PUR-1378
ADDENDUM NO. 2
INVITATION TO BID

THE MARYLAND THEATRE EXPANSION
IN HAGERSOWN, MARYLAND

DATE: Monday, March 26, 2018

A18 EAST ELEVATION
1/4" = 1'-0"

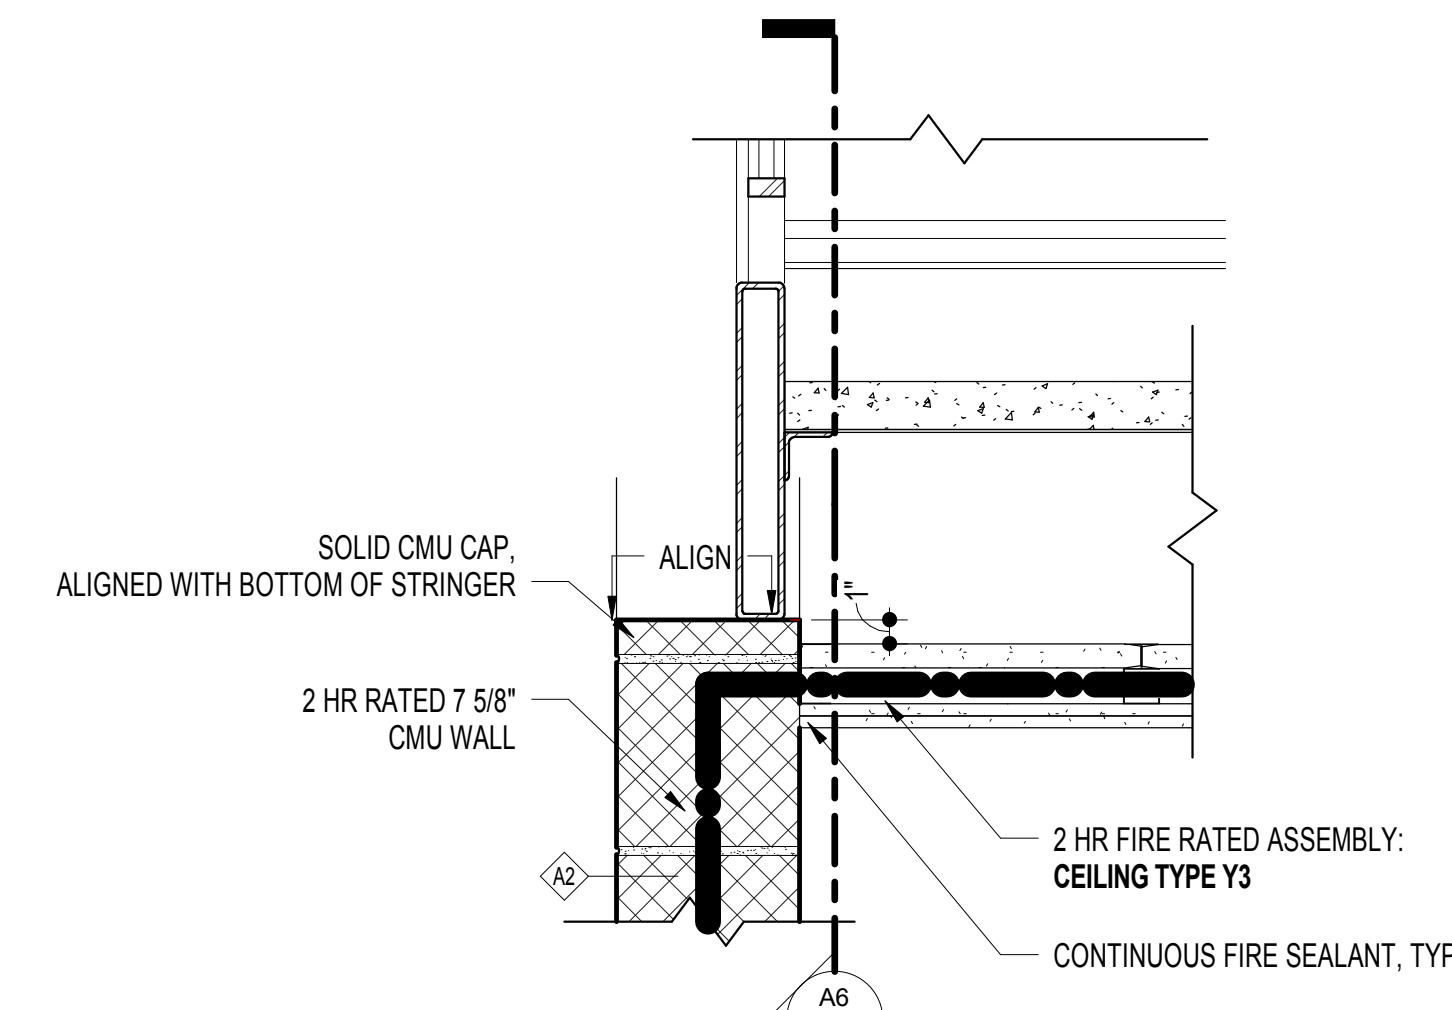
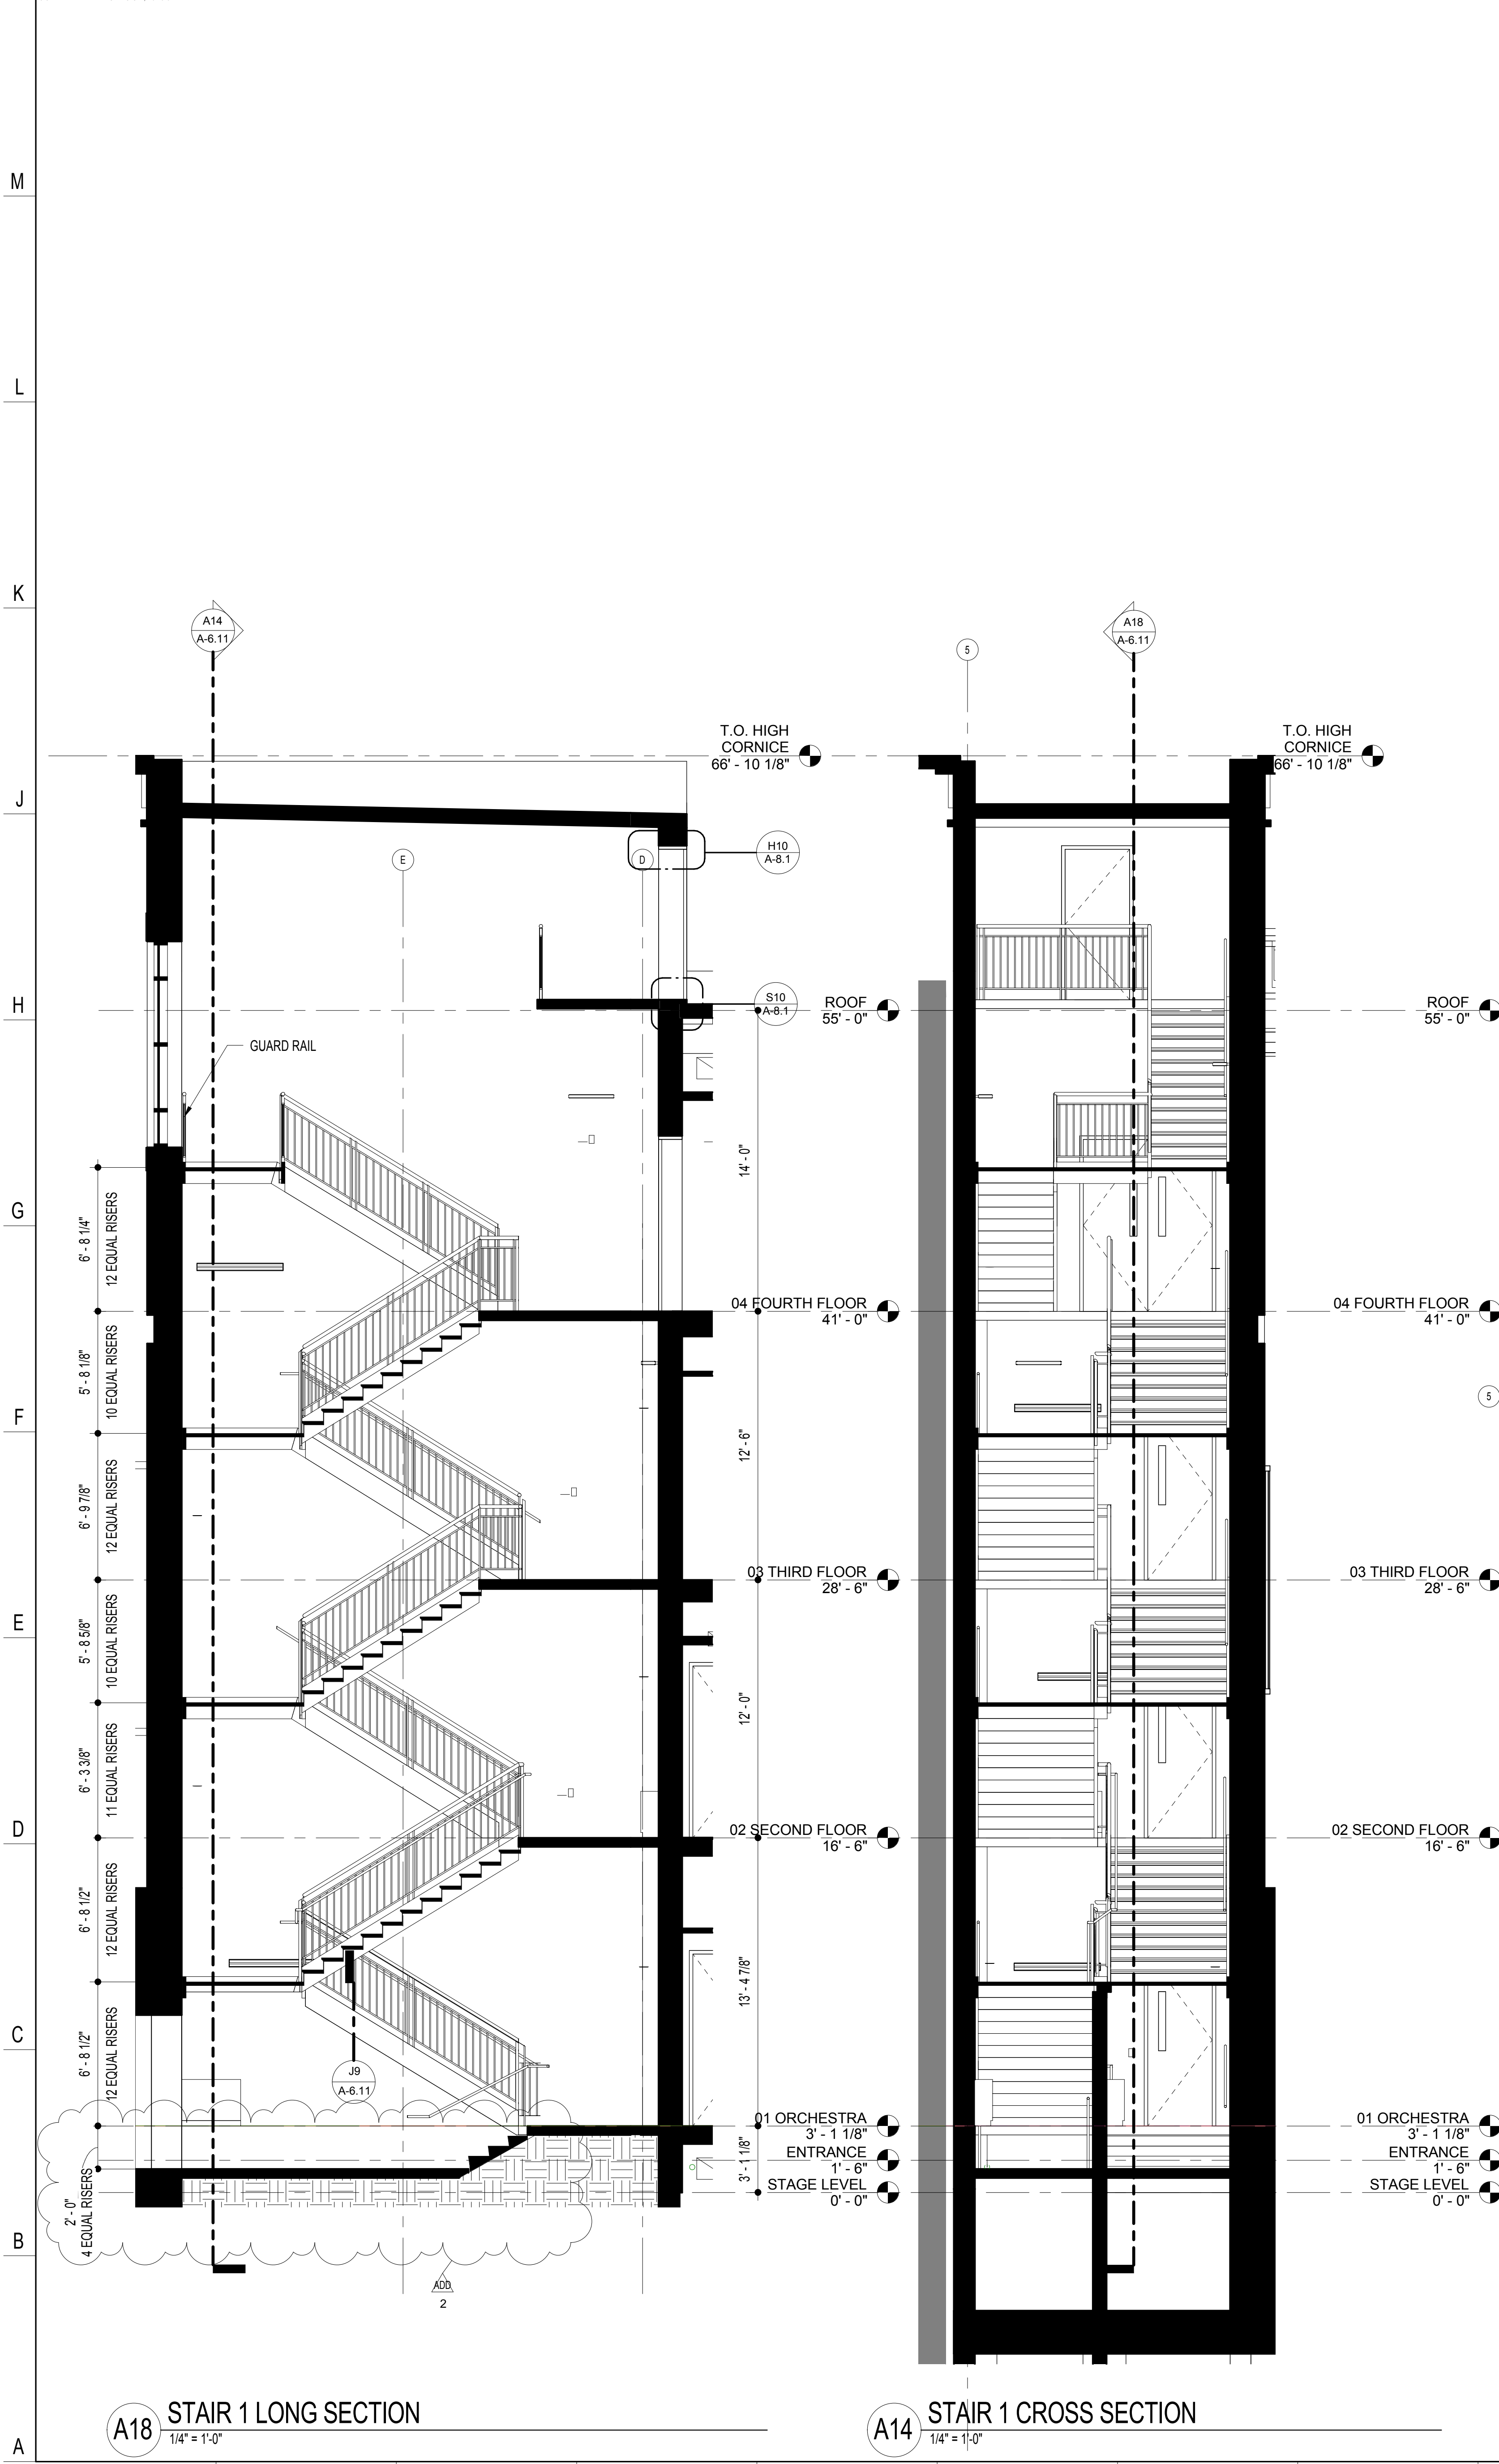
- ITEM NO. 99** SHEET A-3.1 – EXTERIOR ELEVATIONS *(SHEET ATTACHED)*
- REVISE** Revise height of Doors EXS101B, EXS101A and EX100 per sidewalk elevations
